BEFORE THE ENVIRONMENT COURT

CONSENT ORDER

IN THE MATTER of the Resource Management Act 1991
AND of an appeal under section 120 of the Act
BETWEEN LITTLE STREAM LIMITED
(ENV-2015-CHC-005)
Appellant
AND QUEENSTOWN LAKES DISTRICT
COUNCIL
Respondent

Appendix 1

North-West Elevation

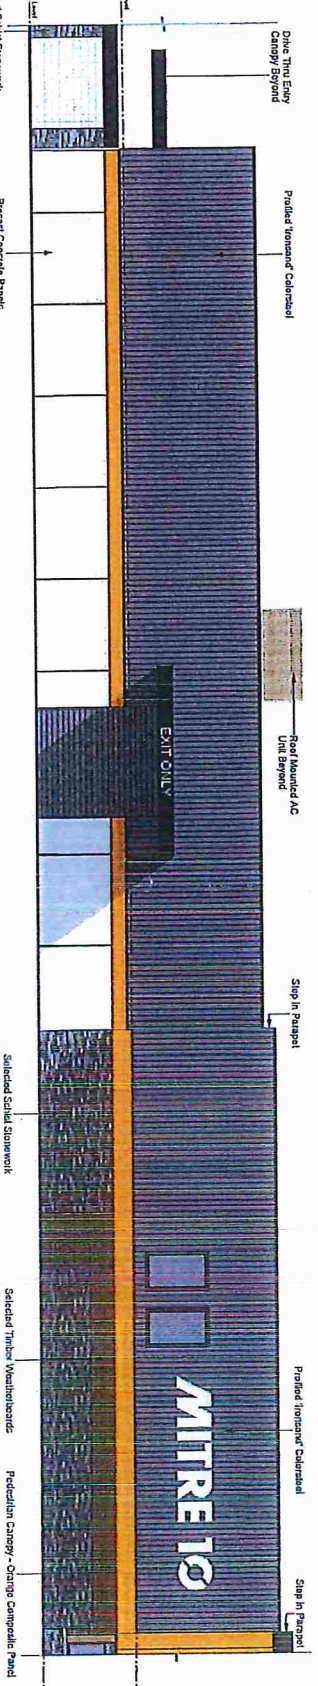
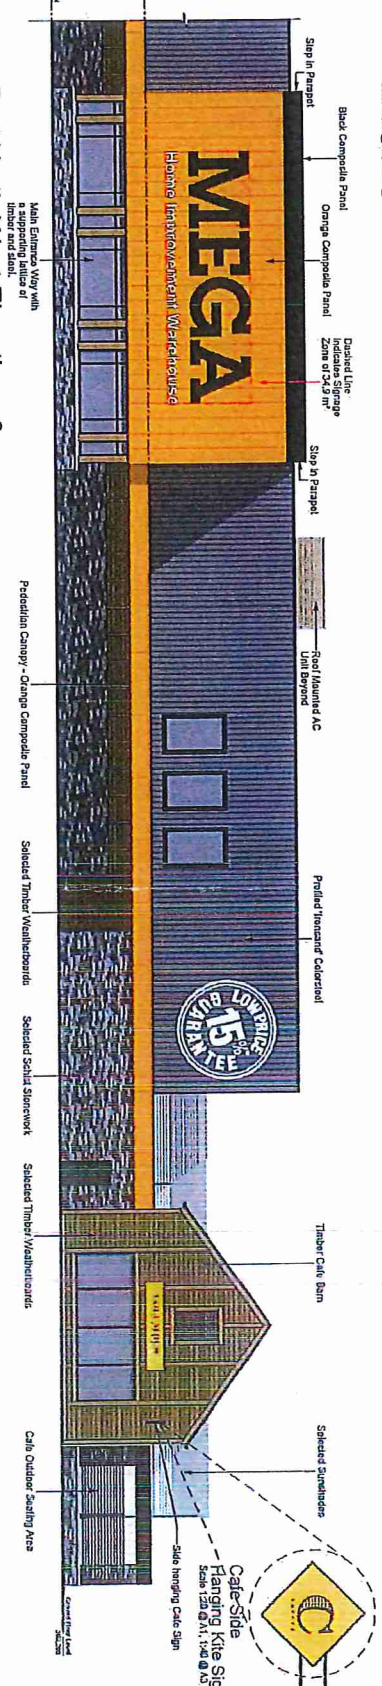
- (1) the appeal is allowed and RM130521 is granted subject to the following amended conditions:
 - (a) Condition 19 is deleted; and
 - (b) Condition 1(e) is amended to read:
“Mason and Wales Drawing No: A100 North-West Elevation Revision C dated 3 June 2014 (Option G)”;
- (2) “Mason and Wales Drawing No: A100 North-West Elevation Revision C dated 3 June 2014 (Option G)” attaches to and forms part of this order;
- (3) for subsequent ease of understanding the resource consent, the respondent reprints the land use consent with all the changes directed under (1) included, so that any reader not familiar with the proceeding can read the resource consent and understand it as a whole, without having to read, interpolate and consider separately changes made by this consent order;
- (4) the appeal is otherwise dismissed.

DATE: 22 May 2014
BY: Sam Lynds
Scale: 1:3000
Original Plan A3
DRAWING & ISSUE No. 2737.22R.11

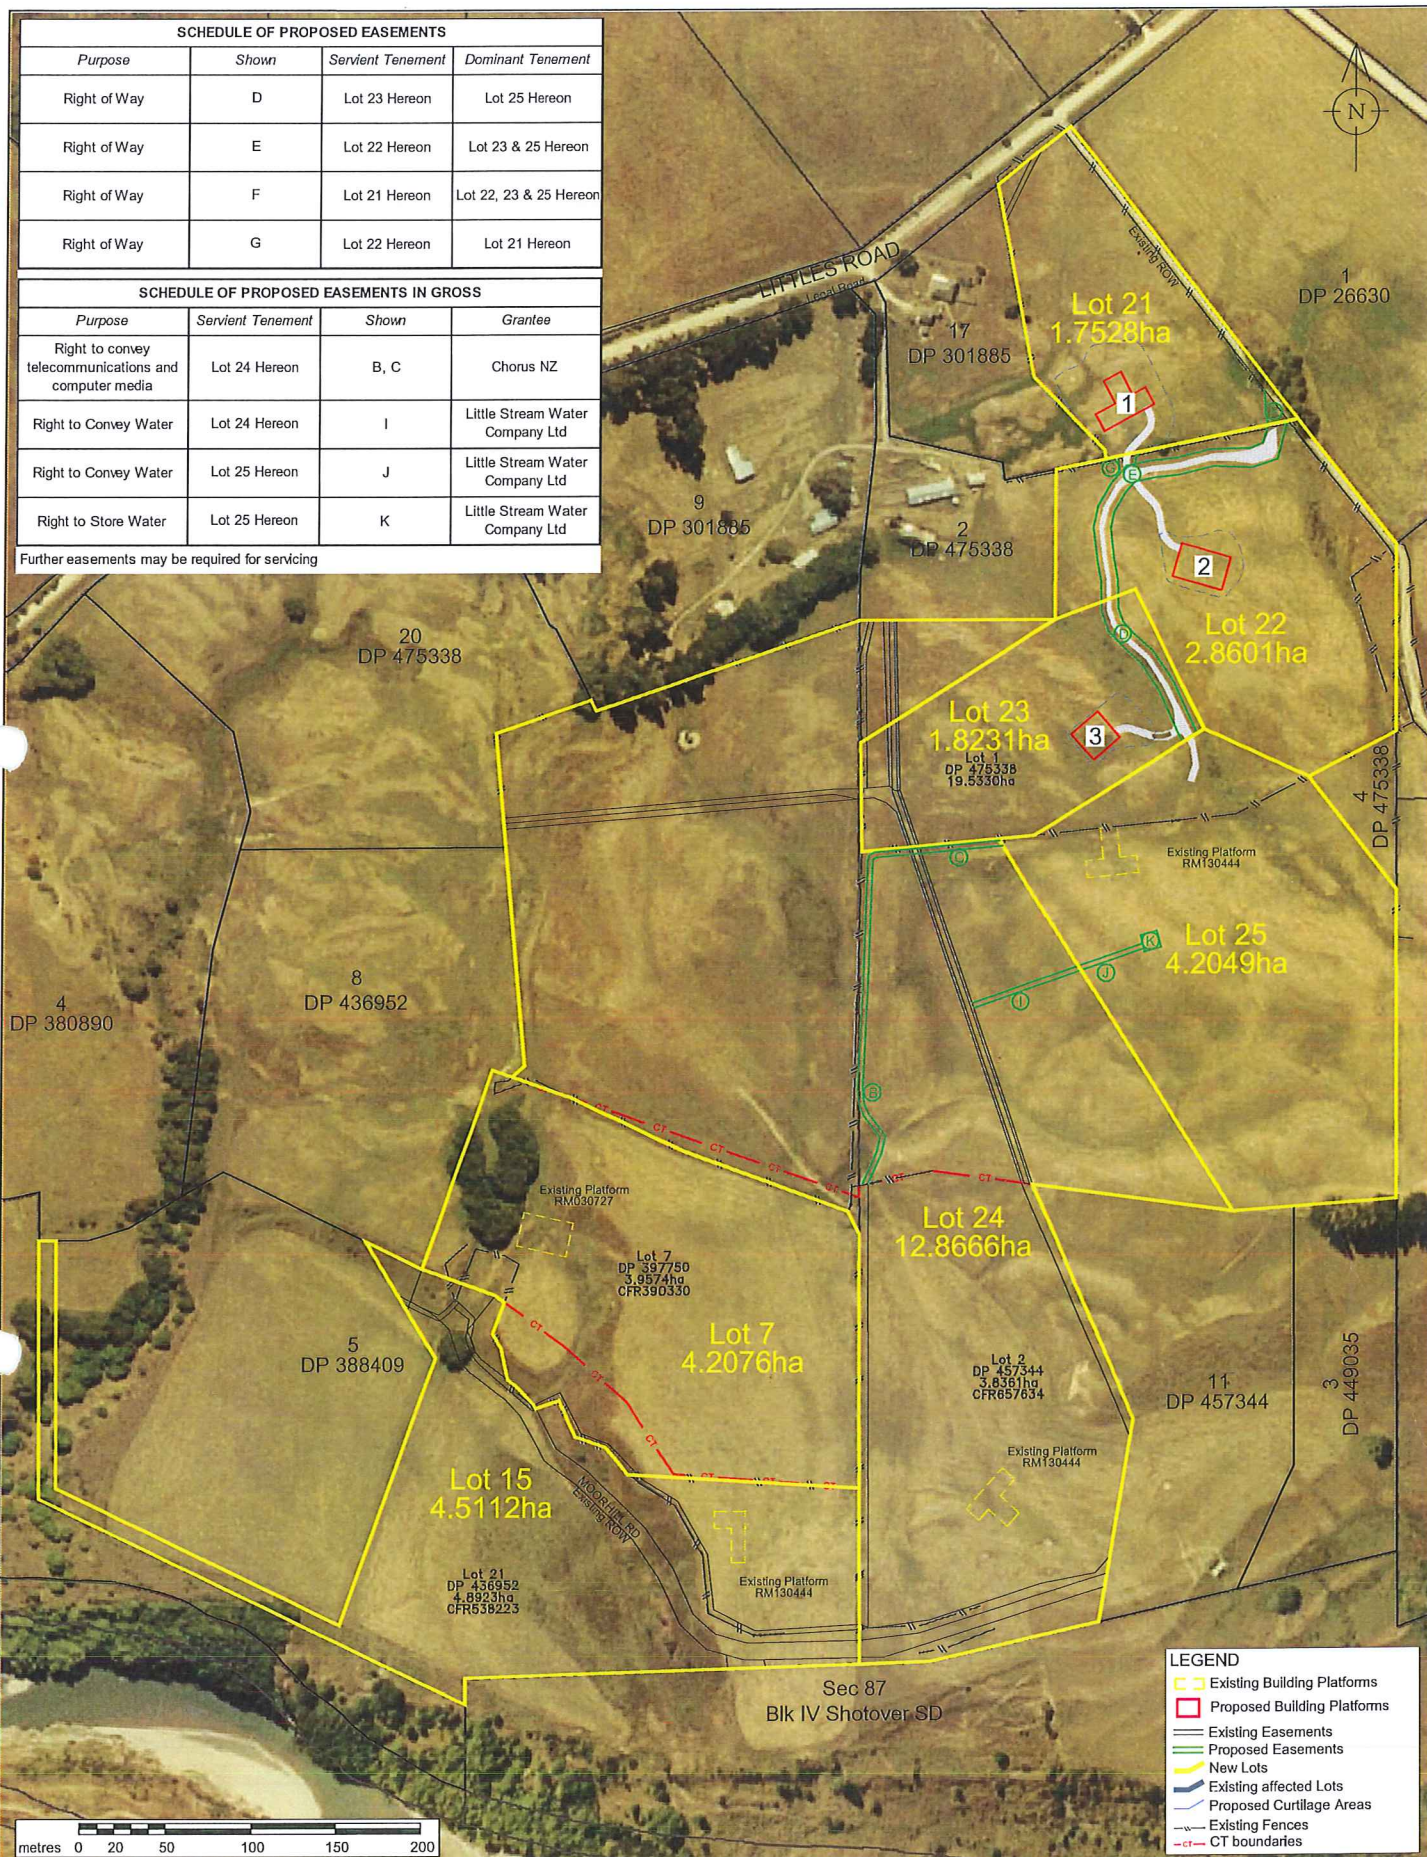
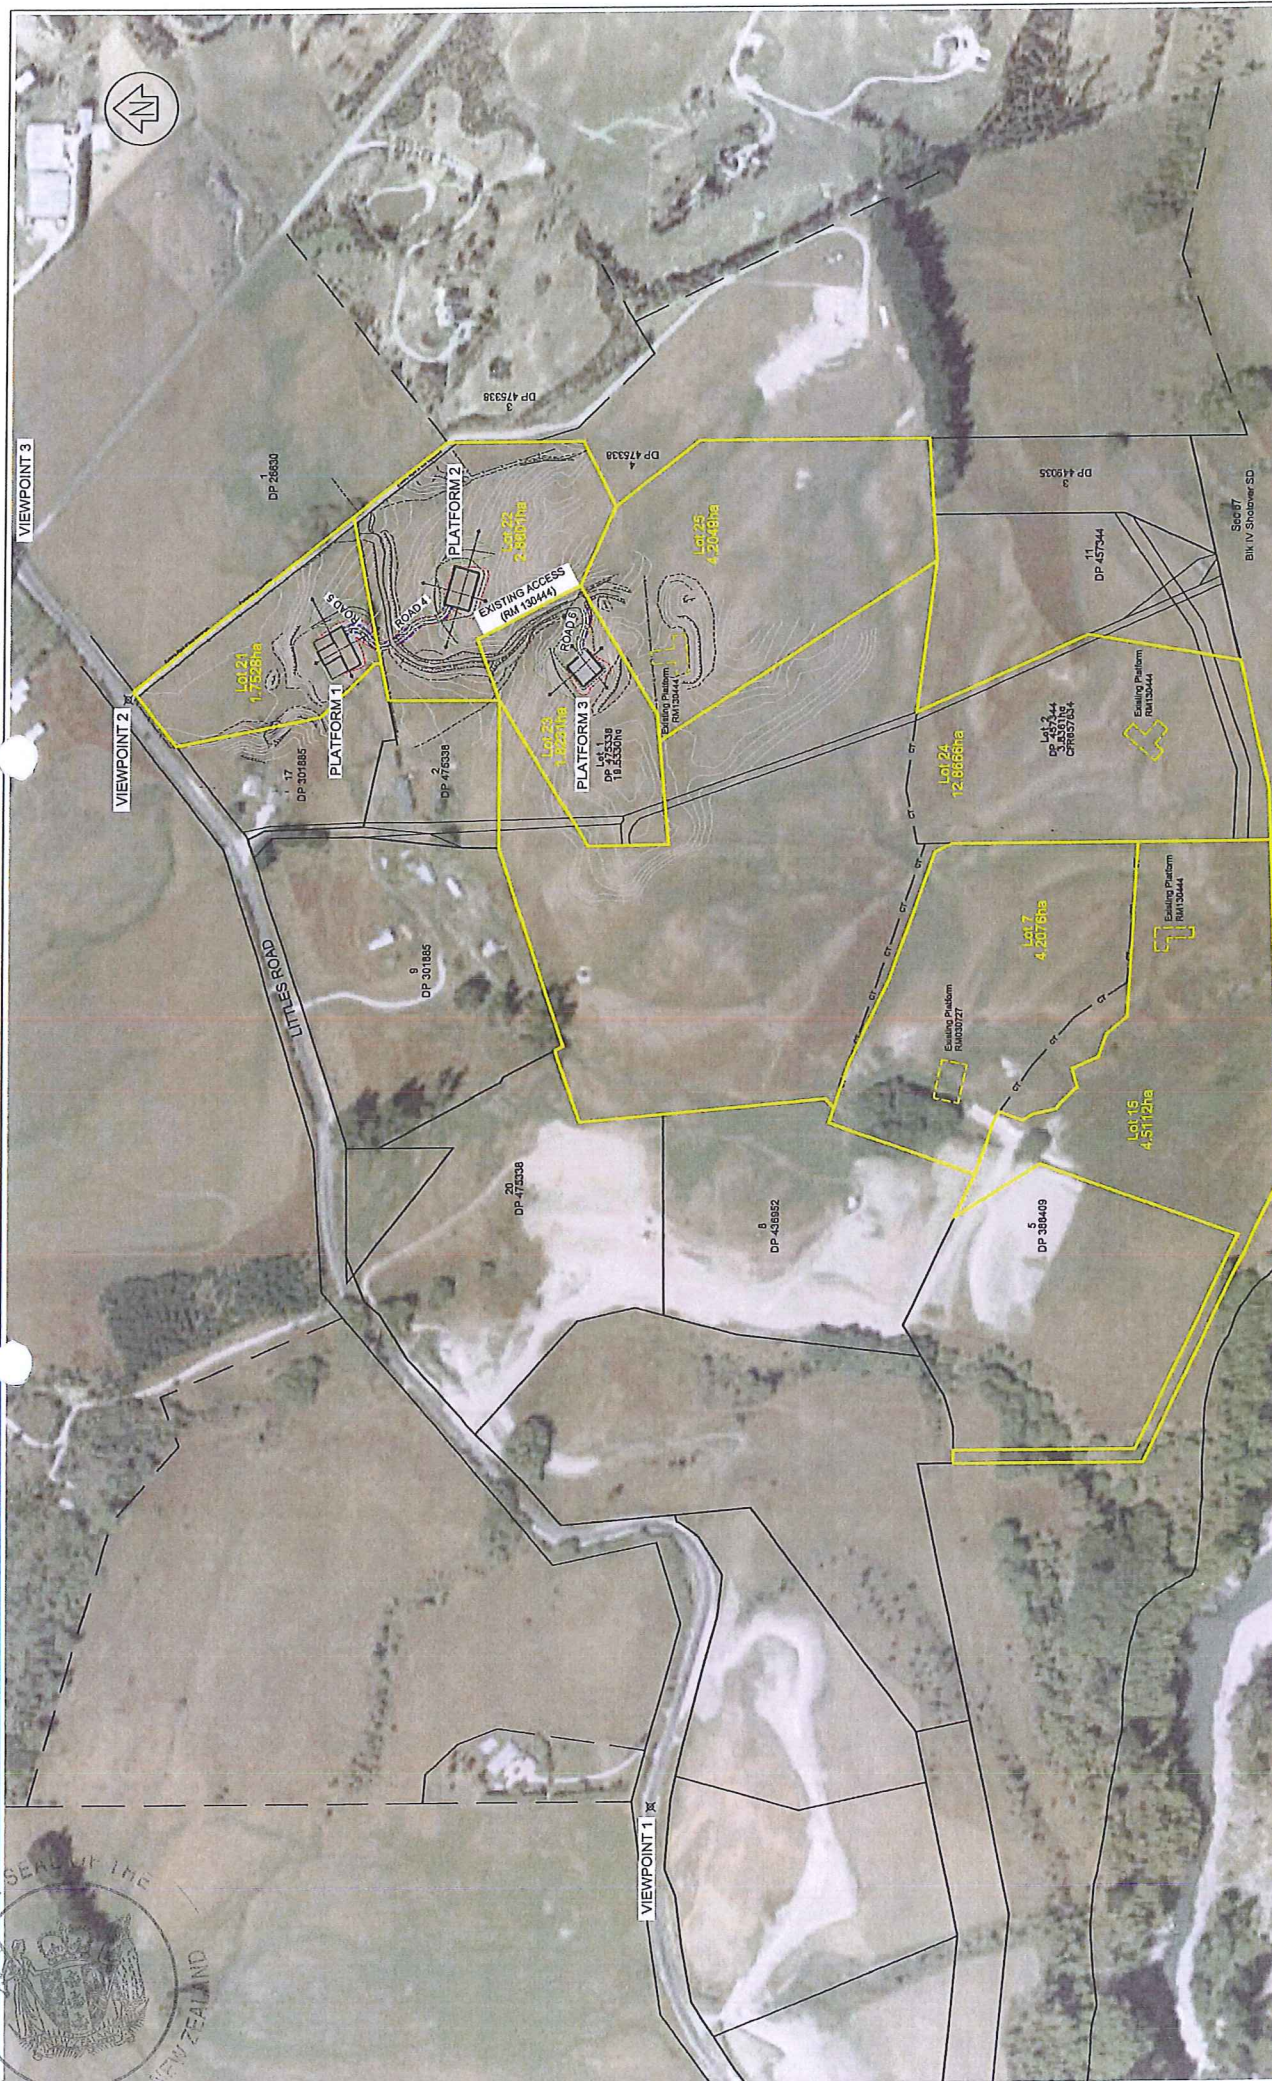
- Aurum Survey Consultants Drawing 2737.22R.1I Revision I dated 19/2/15
- Aurum Survey Consultants Drawing 2737.24R.1D, 2D, 3D, 4D and 5D Revision D dated 24.02.15, and 2737.24R.9C and 10C Revision C dated 24.02.15
- Vivian Espie Structural Landscape Plans for Lot 21, 22, 23 all dated 13/6/14
